7.0 Design Out Crime Officer (DOCO) Report

Re : Merthyr Interchange Link.

Merthyr Tydfil Interchange Link

Road Safety Audit Stage 1 Designers Response

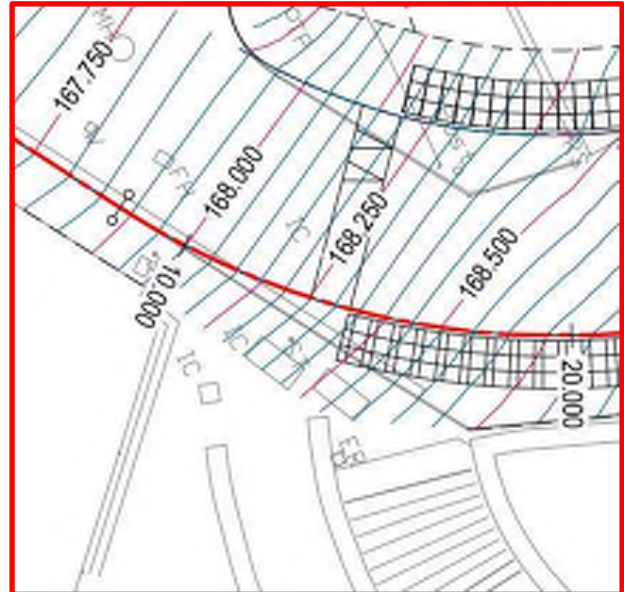
Location: Proposed uncontrolled crossing

Summary: Tripping hazard for visually impaired pedestrians.

Visually impaired pedestrians using the outer handrail on the existing steps will be directed towards the ramped part of the road hump on Masonic Street. Risk of pedestrians tripping at the road hump ramp.

Recommendation

Extend the road hump southwards.

The crossing location has been positioned to direct users straight into the public realm area. Impaired users following the outer handrail will encounter the tactiles before they reach the ramp, also the longitudinal gradient on the northern footway is steep and gets steeper the further south you go. The designer thinks the risk is low and therefore retains the existing layout.

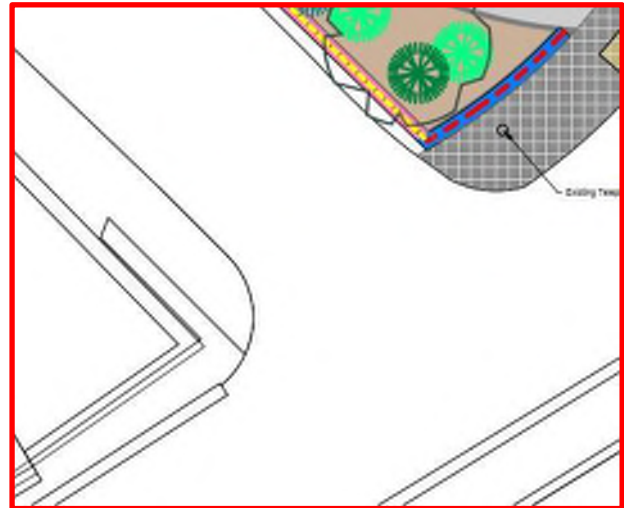
Location: Turning head near uncontrolled crossing

Summary: Trips and falls.

There are no drop kerbs at the connecting footways across the turning head near the crossing. Drop kerbs improves connectivity for mobility impaired users, where failure to provide these facilities increases the risk of pedestrians falls and/or wheelchair users being trapped in the carriageway.

Recommendation

Provide drop kerbs to aid pedestrian movements across the turning head.

Drop kerbs will be provided when we get to detail design stages.
